REGIONAL REVIEW NOTIFICATION

Name of Proposal: 6405 Sugarloaf Parkway DRI 3468

6405 SUGARLOAF DRI Gwinnett County Natural Resources Group Comments October 19, 2021

Stream Buffers

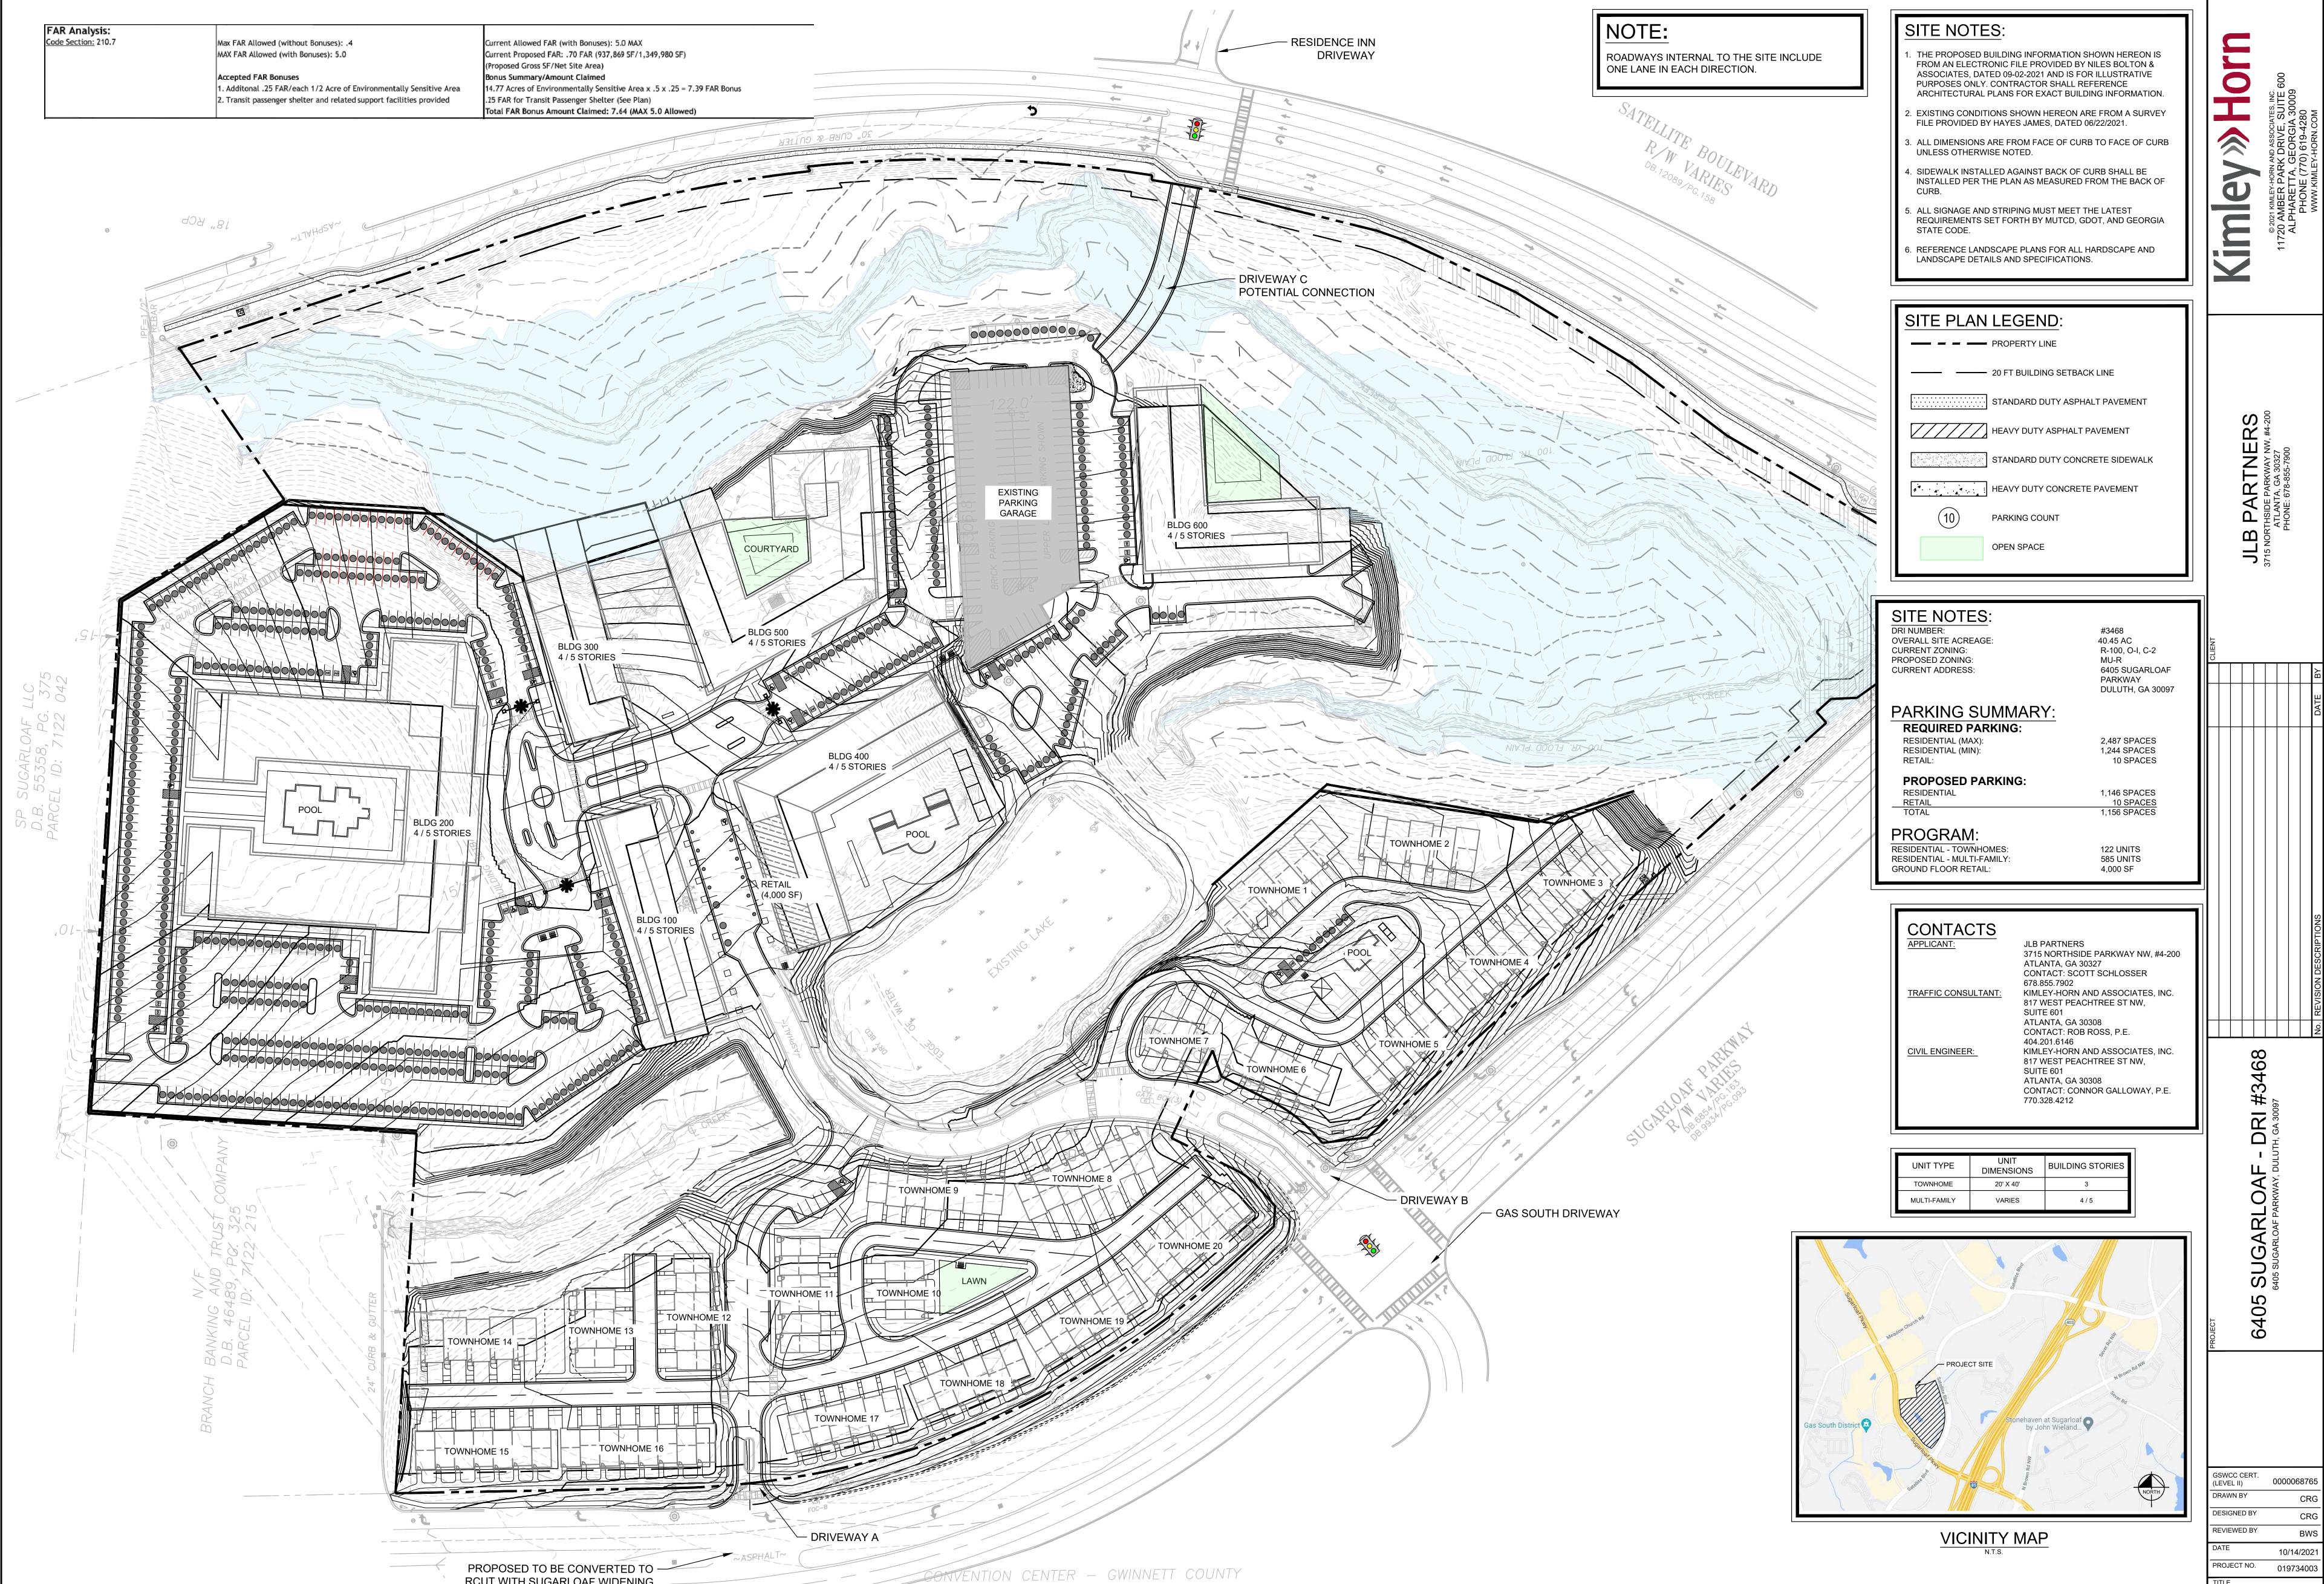
Both the site plan and the USGS coverage for the project area show a perennial blue-line stream and an intermittent tributary on the property, The perennial stream runs along the eastern and southeastern portions of the property, roughly paralleling Satellite Boulevard. The intermittent stream runs north-south just west of the center of the property, joining the perennial stream near the southern end of the parcel. Buffers that appear to be the Gwinnett County Stream Buffer Ordinance 50-foot undisturbed buffer and 75-foot impervious surface setback, as well as the State 25-foot Sediment and Erosion Control buffer are shown on the submitted site plan but are not identified. No intrusions into the buffers along the perennial stream are shown, except for a proposed driveway connection, which, as a transportation crossing, is allowed under the Gwinnett buffer ordinance. Proposed grading shown along the intermittent stream extends into the 75-foot setback and may require a variance under the Gwinnett ordinance. The road access (shown as Driveway B on the plans) is existing. Work around the lake is affected by the Gwinnett ordinance, as it does not include ponds or lakes. Any other intrusions into the buffers may require variances from the County or the State. Any unmapped streams on the property may also be subject to the City and State buffers. Any unmapped waters of the state will also be subject to the State 25-foot Sediment and Erosion Control buffer.
